REVISION TRANSMITTAL

This sheet transmits Revision 1 to MEB-27-02, which:

FLIGHT CONTROLS - ELEVATOR TRIM-TAB PUSH-PULL TUBE HARDWARE REPLACEMENT

MEB-27-02
Page 1 of 8

Figure 1. Elevator Trim-Tab Push-Pull Tube Hardware (Sheet 1)

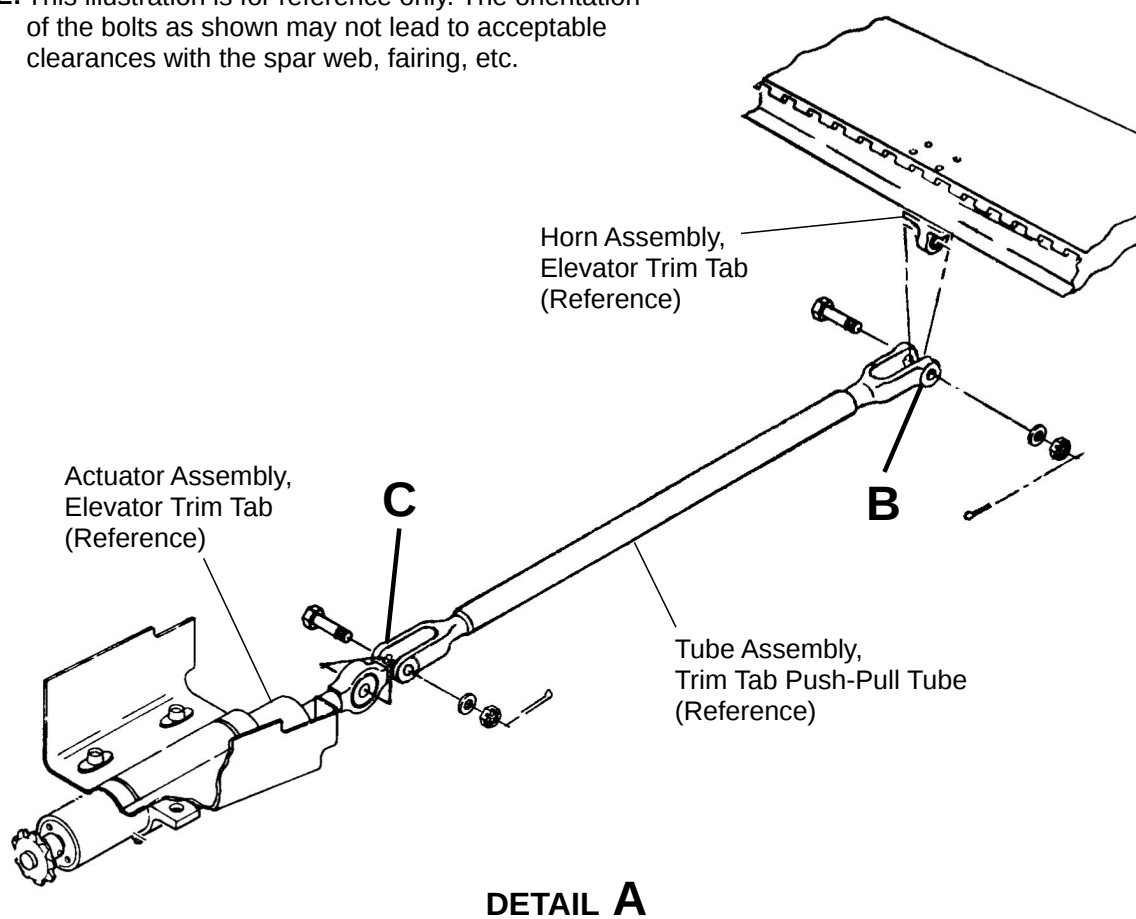
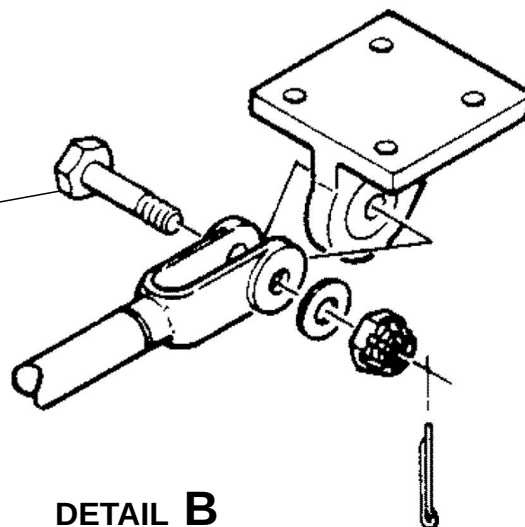
4. (Refer to Figure 1, Sheet 1 and Sheet 2.) Install the NAS464P3-8 Bolt, NAS1149F0332P Washer, MS17826-3 Nut and MS24665-132 Cotter Pin in the elevator trim tab actuator rod end to push-pull tube connection as follows:

NOTE: The bolt grip length may be adjusted to the next longer grip length (NAS464P3-9) to permit proper installation of the castellated nut and cotter pin. This may require extra washers (NAS1149F0316P and/or NAS1149F0332P) for proper alignment of the castellated nut cotter pin slot and the cotter pin hole in the bolt.

NOTE: It is permissible to substitute the NAS464P3-X bolt with a NAS6203-X bolt.
 - A. (Refer to Figure 1, Sheet 1 and Sheet 2.) Install the NAS464P3-8 Bolt in the elevator trim tab actuator rod end to push-pull tube connection in the orientation (i.e., bolt head inboard or outboard) which yields the greatest clearance with the spar web cut-out and any other structures.

Figure 1. Elevator Trim-Tab Push-Pull Tube Hardware (Sheet 2)

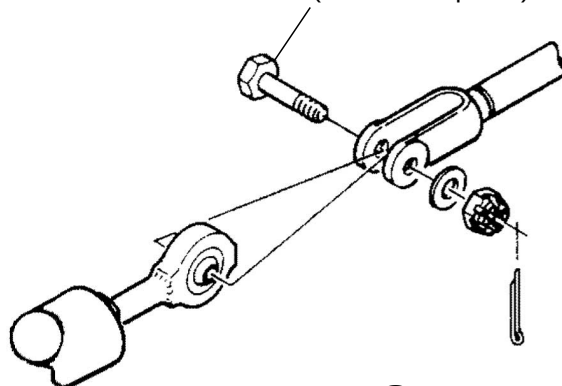
NOTE: The bolt grip length may be adjusted to the next longer grip length (NAS464P3-9) to permit proper installation of the castellated nut and cotter pin. This may require extra washers (NAS1149F0316P and/or NAS1149F0332P) for proper alignment of the castellated nut cotter pin slot and the cotter pin hole in the bolt.

NAS464P3-8 or
NAS464P3-9
Bolt
(1 Required)
NAS1149F0332P
and/or
NAS1149F0316P
Washer
(1 or More as Required)
MS17826-3
Nut
MS24665-132
Cotter Pin
(1 Each Required)

NAS464P3-8 or
NAS464P3-9
Bolt
(1 Required)
NAS1149F0332P
and/or
NAS1149F0316P
Washer
(1 or More as Required)
MS17826-3
Nut
MS24665-132
Cotter Pin
(1 Each Required)
